**Stanley Park Wayfinding and Signage System  
Signage Review Audit**

Karo Design Vancouver, 6 April 2004

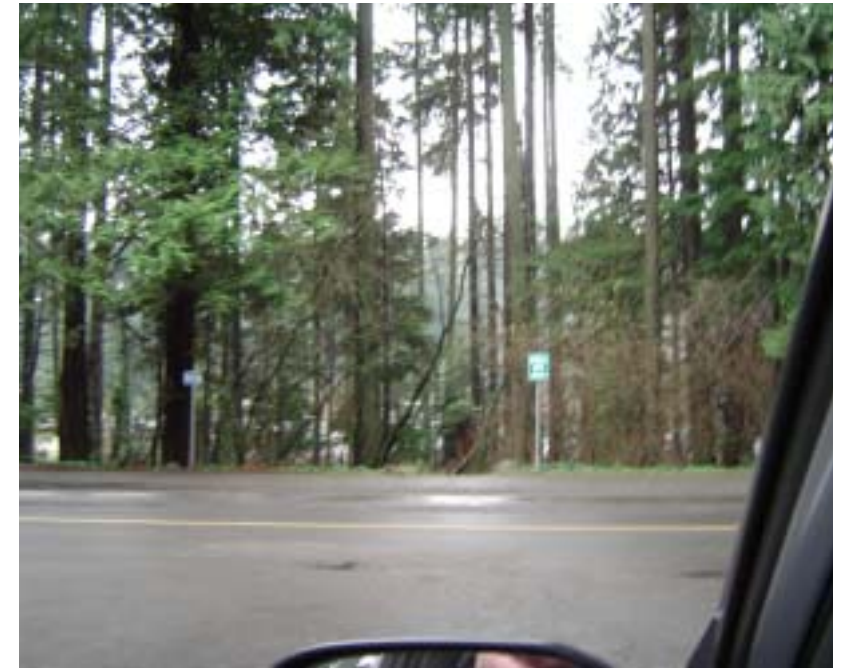
5. Signage obscured by foliage and garbage receptacle.
6. Signage obscured by lamp post and stairs.
7. Low shoulder installation obscure sign.
8. Signage installed on road curve and low shoulder is difficult to see.
